SUBJECT: Invitation for Bid #13-1324-OV
McCollum's Lake Subdivision Resurfacing Project and
Leffingwell Avenue, From US 301 to Cedar Street
(aka 9th Street) (CDBG Project)

ADDENDUM #1

April 18, 2013
Invitation for Bid #13-1324-OV
McCollum's Lake Subdivision Resurfacing Project
and Leffingwell Avenue, From US 301 to Cedar Street
(aka 9th Street) CDBG Project

DETAILS

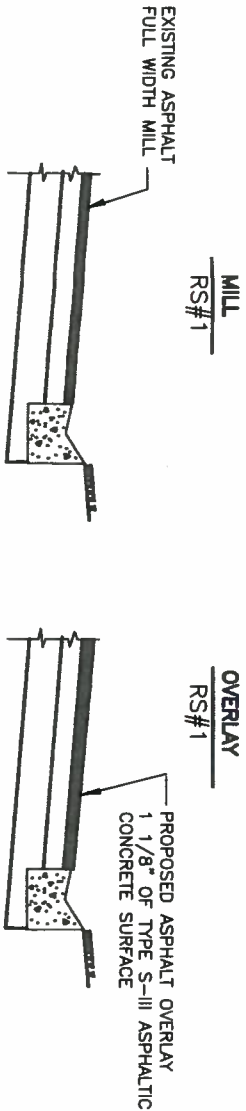
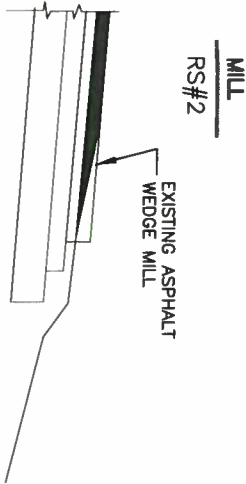
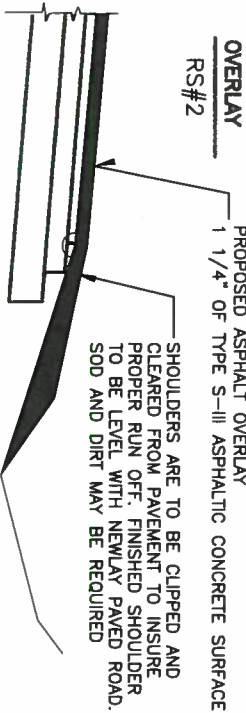
Bidders Note: Option #2, Typical Sheet #4 has been modified to show a wedge mill. PDFs of revised sheets, #4, 5 and #10 shall be made a part of this Addendum No. 1

Q4. Does this project require Thermo Plastic Pavement Markings?

- THERMO PLASTIC NOTE REQUIRED.

NOTE: SHOULDER WORK MAY BE REQUIRED WHEN NO CURB IS PRESENT

A4. No, this project does not require Thermo Plastic Pavement Markings. See note on modified Plan Sheet #4.

NO.	REVISION DESCRIPTION	BY	DATE
1	THERMO NOTE	BM	4/12/13
1	WEDGE MILL	BM	4/12/13
1	SHOULDER	BM	4/12/13

Signature & Date
SHEET 5

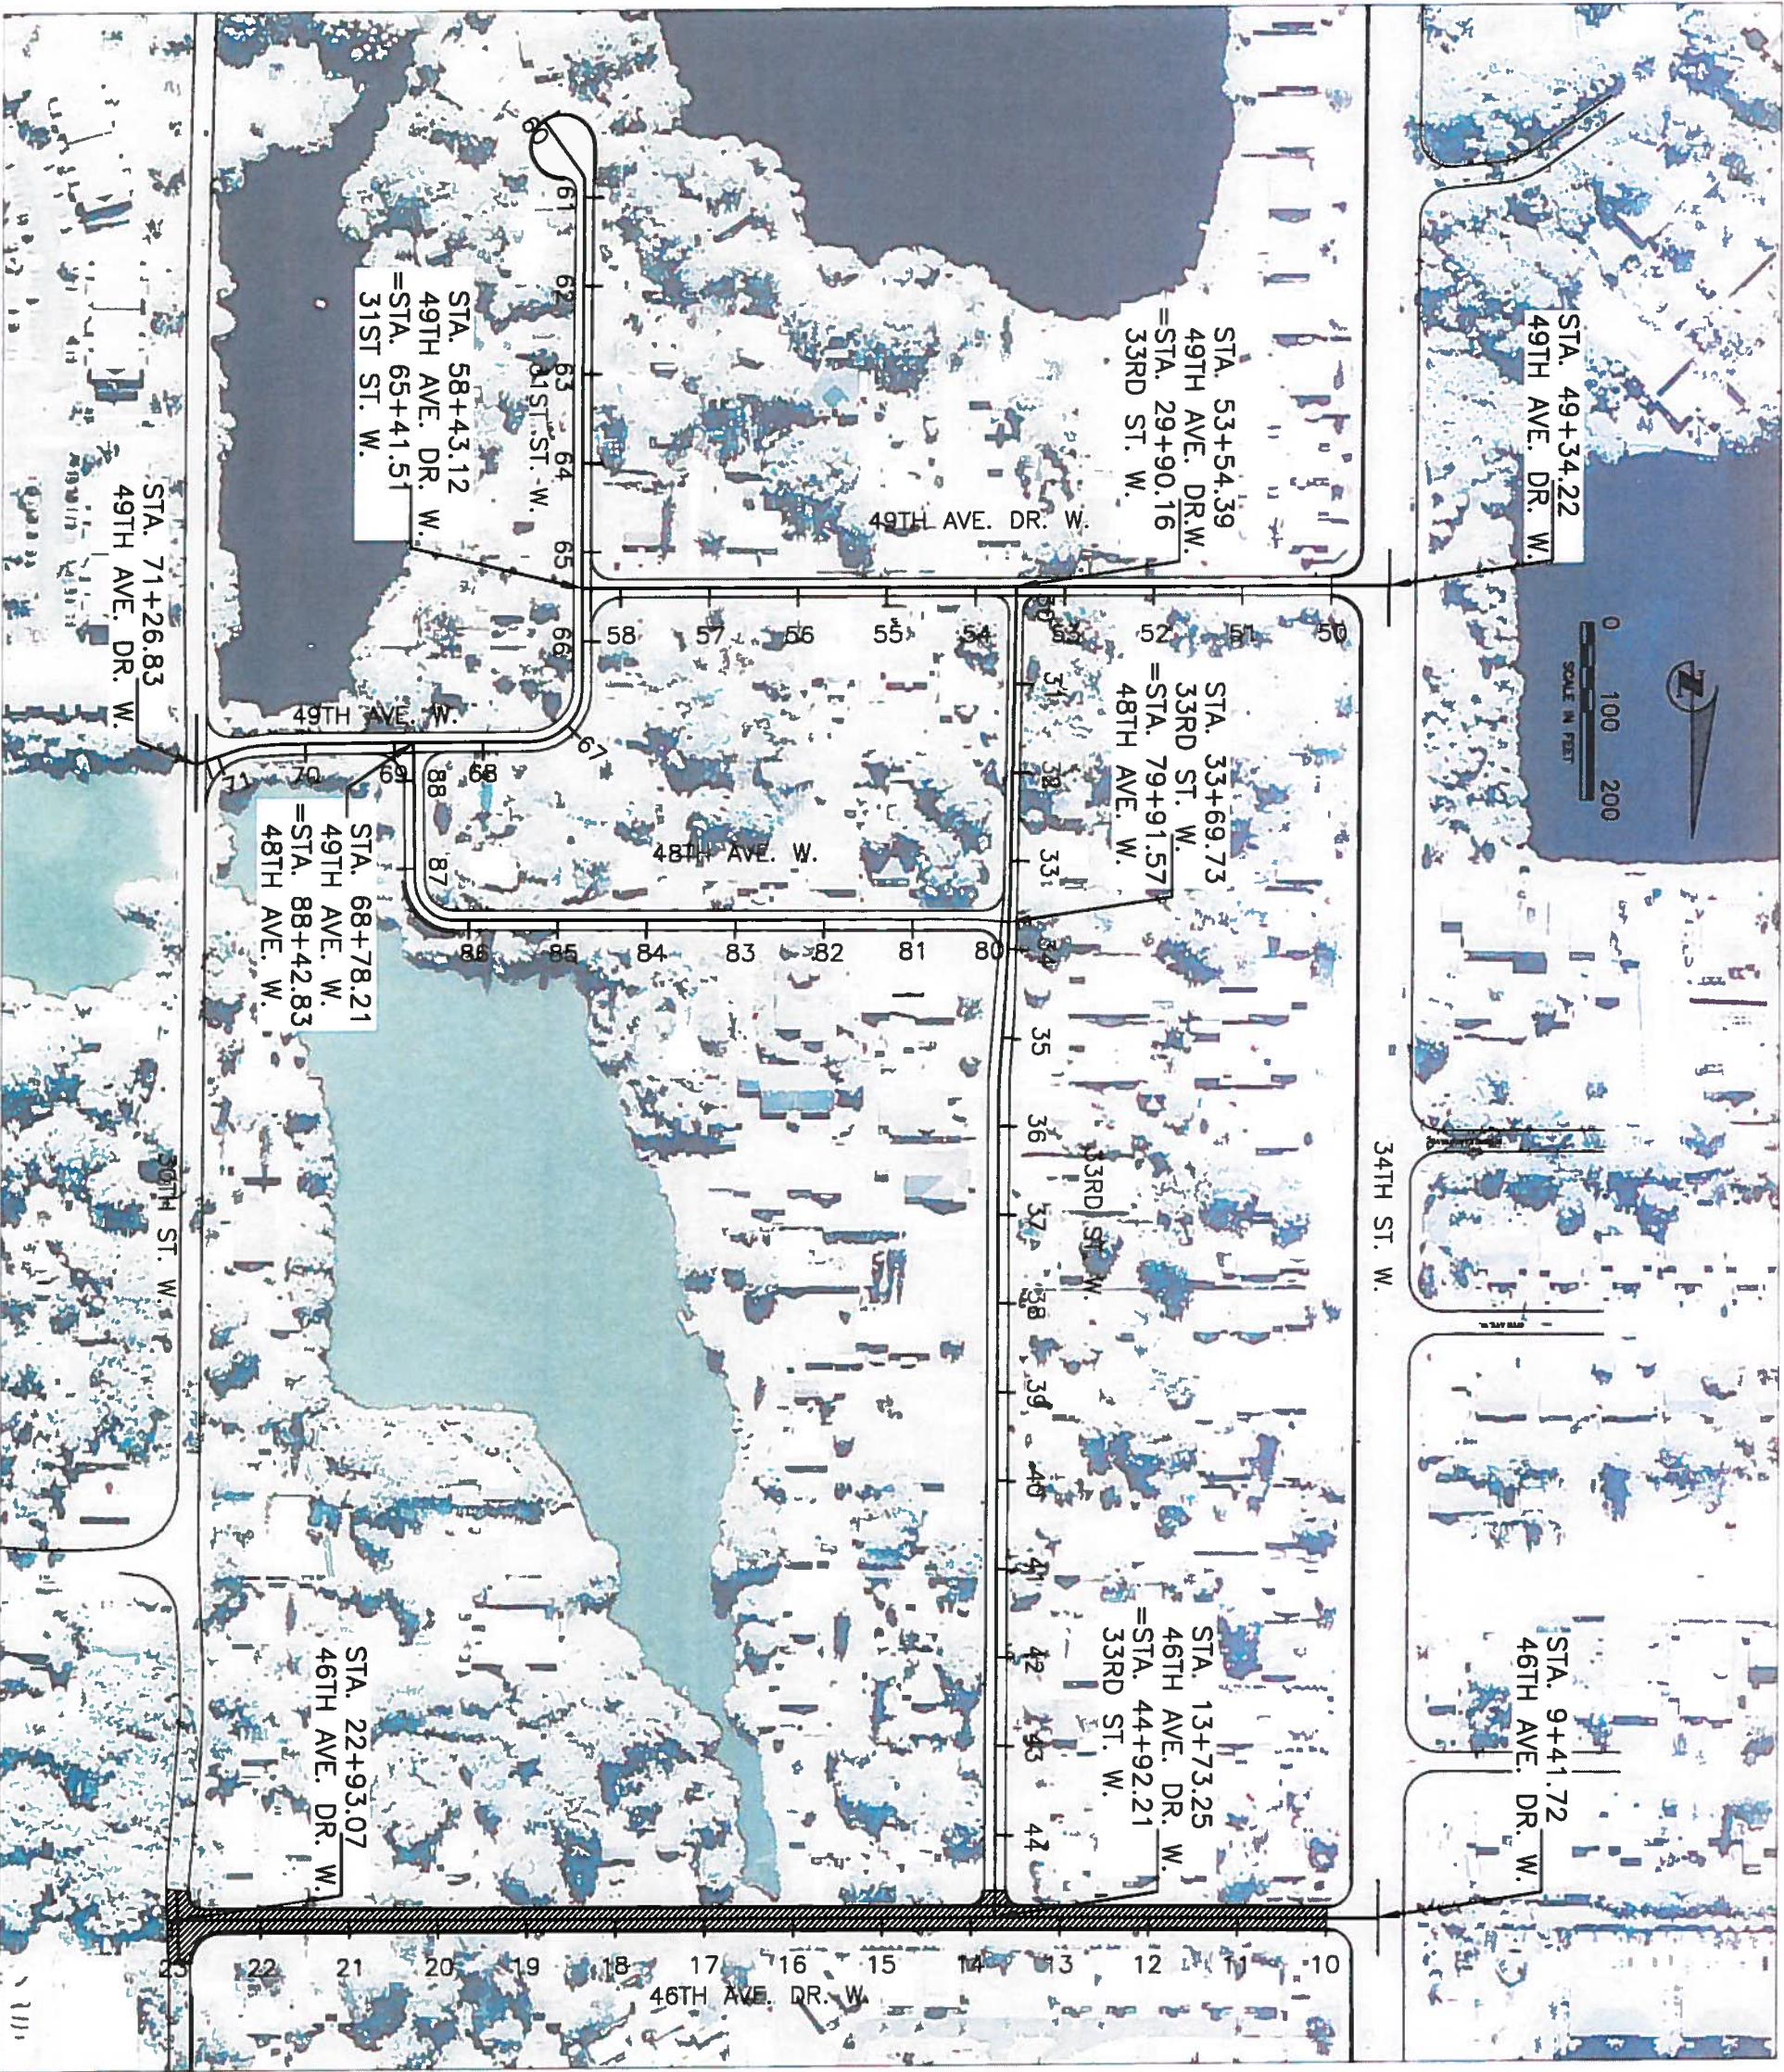
Q3. Please provide clarification as to the whether or not the cul-de-sac will be edge milled.

A3. Plan sheets #5 and #10 have been modified to show the edge milled in the cul-de-sac.

NO.	REVISION DESCRIPTION	BY	DATE
1	REMOVE HATCHING	BM	4/12/13
PROJECT #	17B-0019904		
SURVEY #	N/A		
SEC./TWN./RGE	S.10/T.35/R.17		
SCALE	AS SHOWN		
SURVEYED	N/A		
DESIGNED	CB/BM		10/25/2012
DRAWN	CB		10/25/2012
CHECKED	BM		10/25/2012
